WOLF CREEK NUCLEAR OPERATING CORPORATION

ET 10-0038

Subject: Docket No. 50-482: Response to Second Request for Additional Information Regarding License Amendment Request to Revise Technical Specification 3.3.2, "Engineered Safety Feature Actuation System (ESFAS) Instrumentation"

Response to Second Request for Additional Information

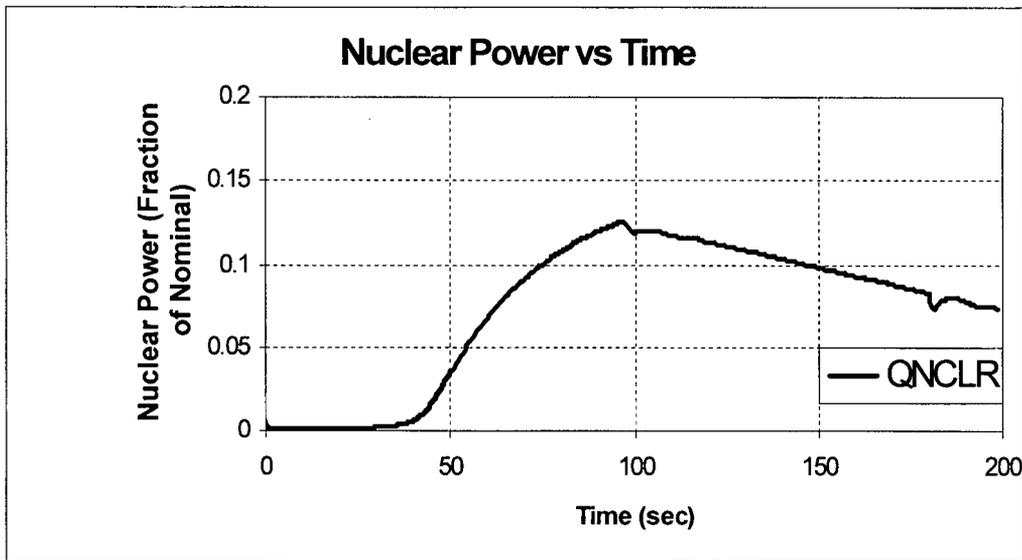
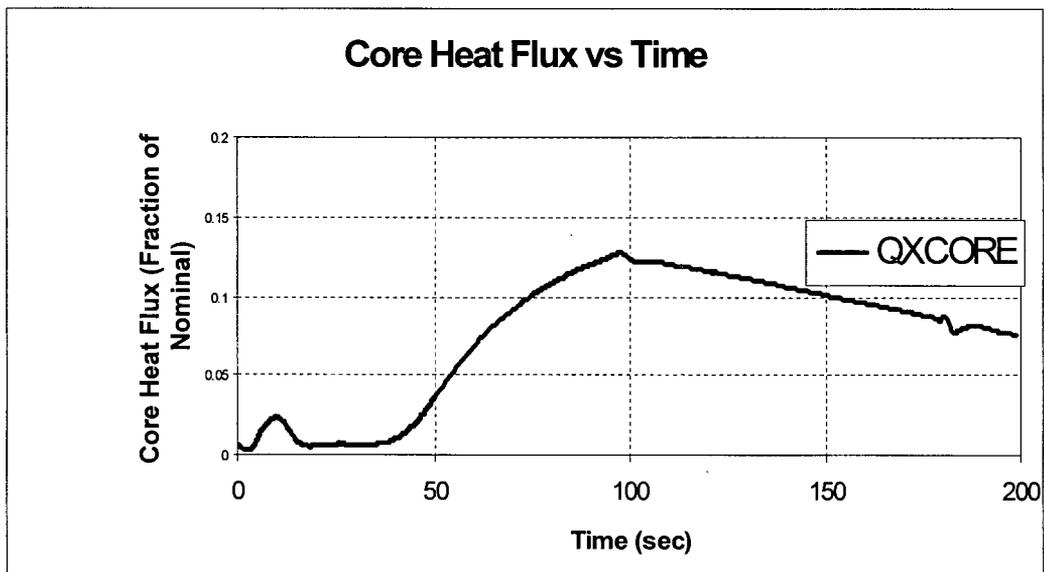
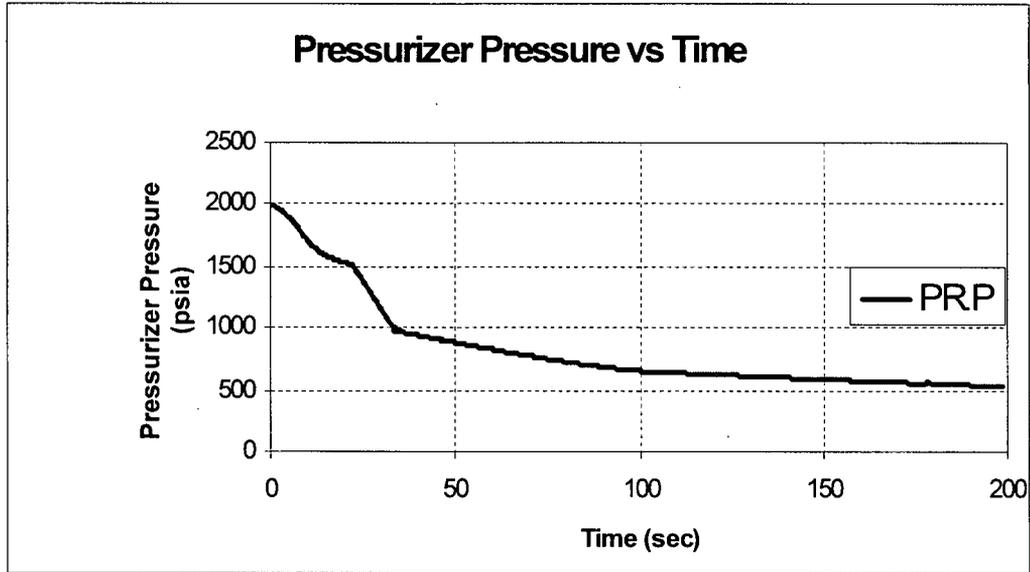
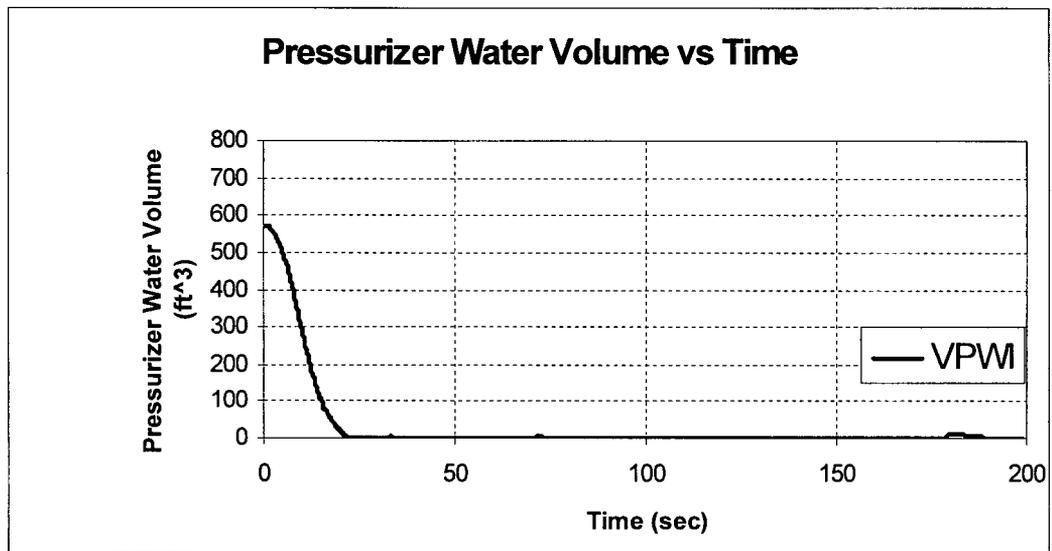
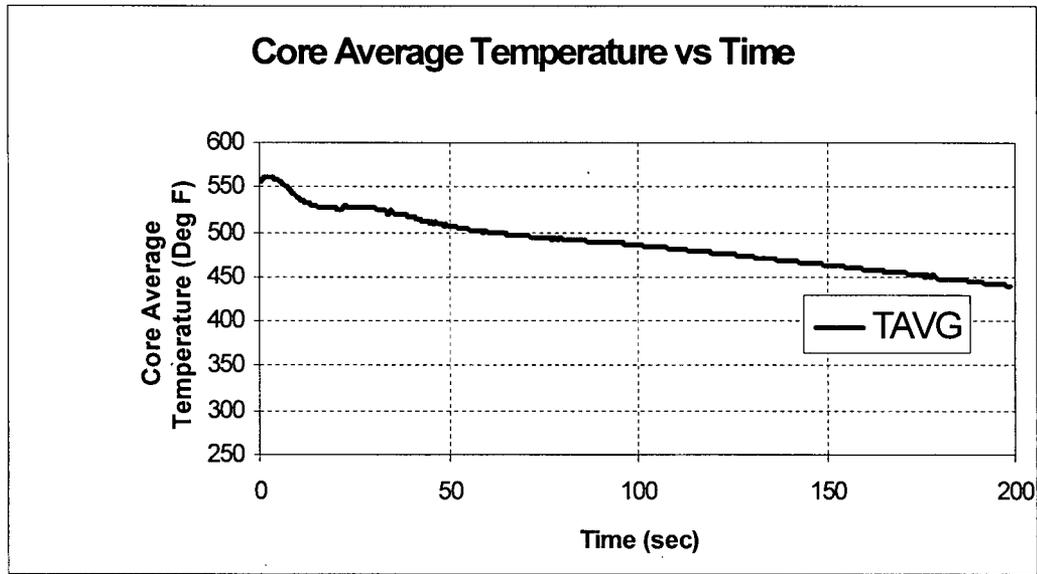
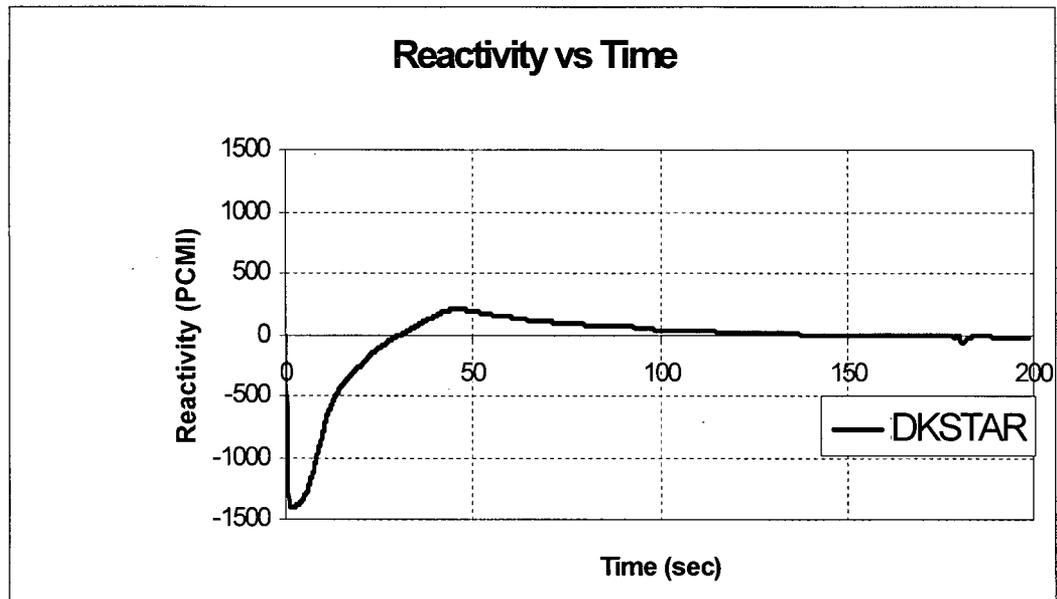
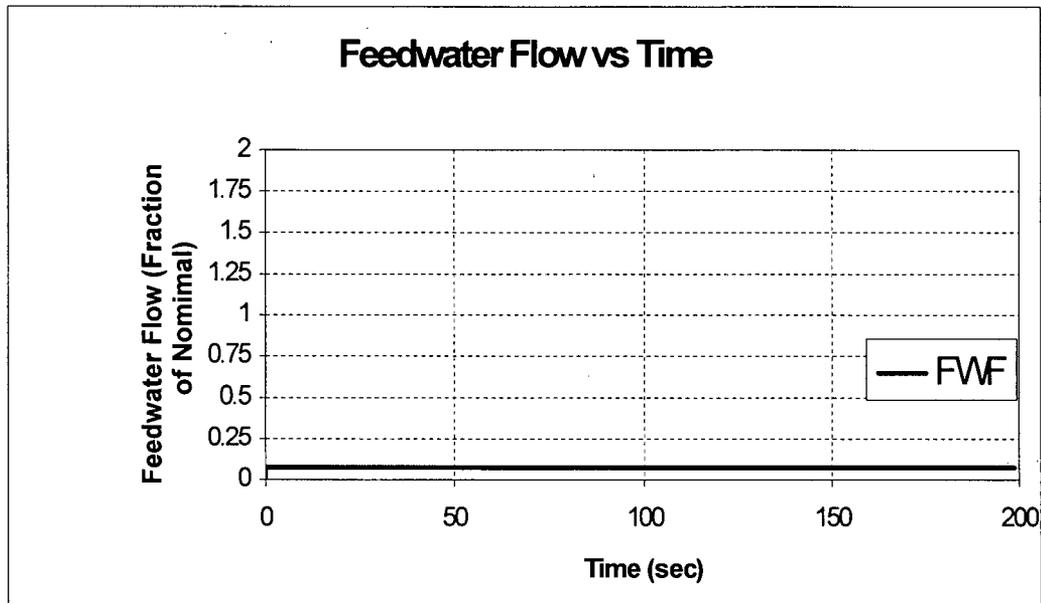
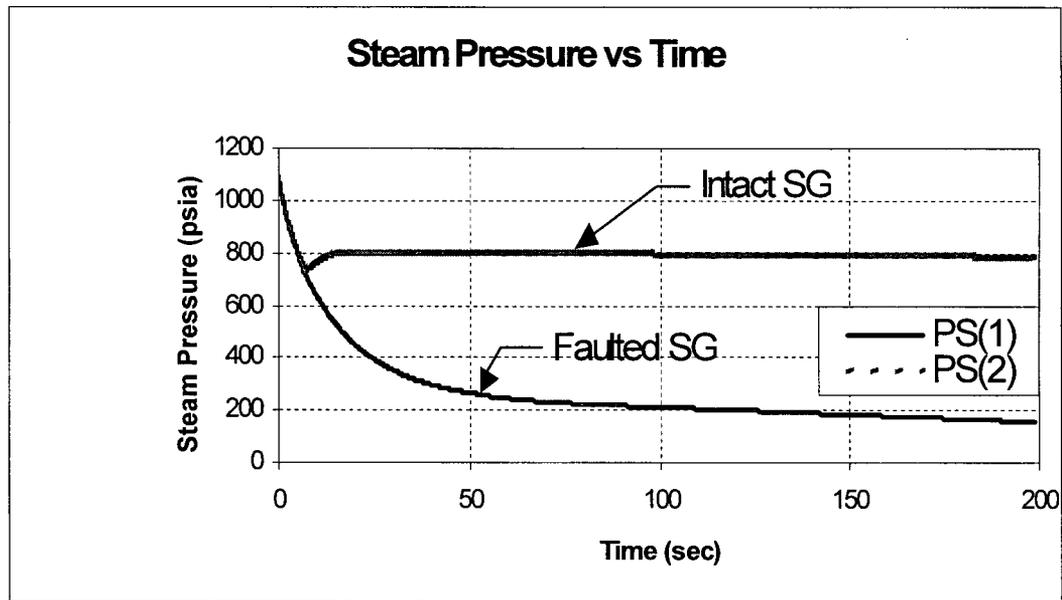
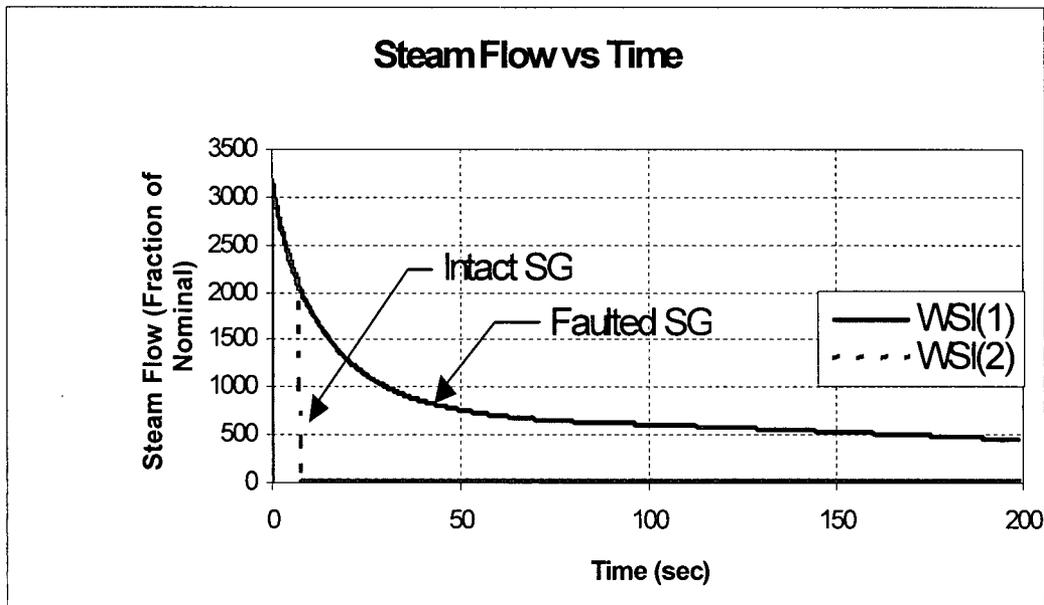
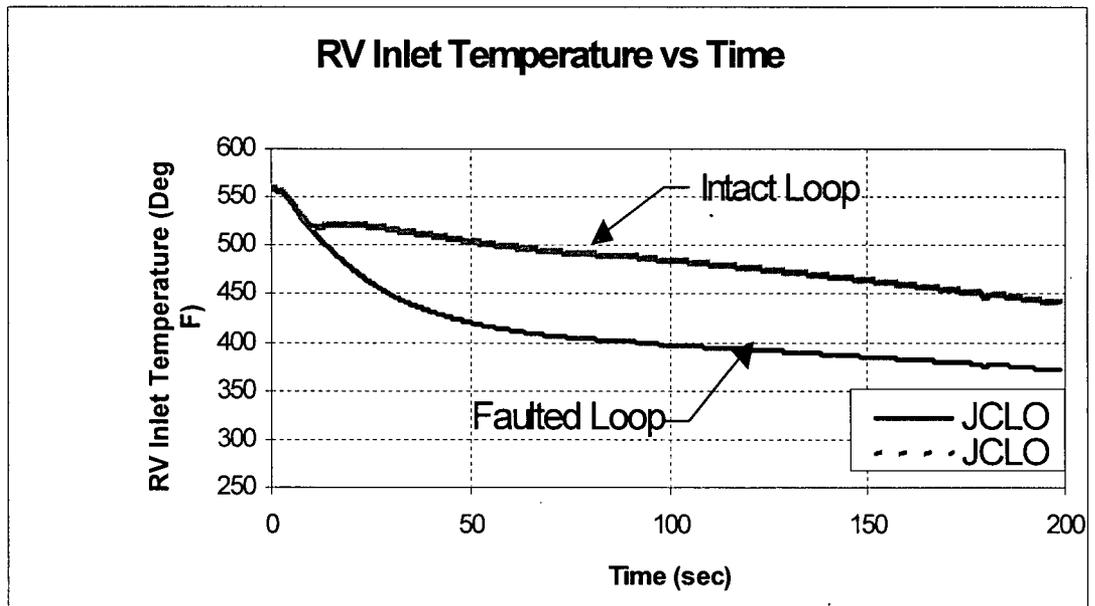
- 3. The licensee's response to RAI 4 discussed an analysis of the steam line break (SLB) event initiating from Mode 3 below P-11 with no feedwater isolation. Please provide a description of the SLB analysis. The requested information should include the results of the analysis, a sequence of the events, a discussion of the methods and computer code used in the analysis, and a discussion of the compliance with the restrictions and limitations in the NRC safety evaluation report approving the methods and code. Please identify the key parameters considered and discuss the bases of the selection of the values (including measurement uncertainties and parameter fluctuation around the normal values) for the initial plant conditions that minimize the margin to acceptable limits.*

Table 3-1 presents a comparison of the consequences of the case scenarios described above. Note: The reference scenario (Case 1) differs from the other cases because SI and the associated feedwater isolation are credited. The time sequence of event for Case 2 is provided in Table 3-2. Figures 3-1 through 3-10 show the transient results for the key plant parameters as a function of time for Case 2: full double-ended rupture with an initial boron concentration of 386 ppm, crediting the steam line isolation by the Steam Line Pressure Negative Rate – High trip Function.

1. The combined effect of the negative reactivity associated with the initial RCS boration requirement to meet the minimum shutdown margin and the steam line isolation provided by the Steam Line Pressure Negative Rate – High trip Function to limit the steam blowdown is more than sufficient to limit the core power excursion following a return to criticality. As a result, the consequences of a postulated SLB event occurring in MODE 3 below P-11 with SI being blocked would be bounded by the current limiting SLB scenario initiating from HZP conditions with a 0 ppm boron concentration.

2. For a smaller steam line break ($< 0.2 \text{ ft}^2$), the steam line depressurization rate may not be large enough to activate the Steam Line Pressure Negative Rate – High trip Function. However, the cooling effect associated with the slower steam blowdown would be less severe. Consequently, the core may still have a chance to return to criticality, but the subsequent power excursion would be limited by the negative reactivity associated with the initial RCS boron concentration. This conclusion is inferred by observing the transient results of the Cases 4 and 5 scenarios.
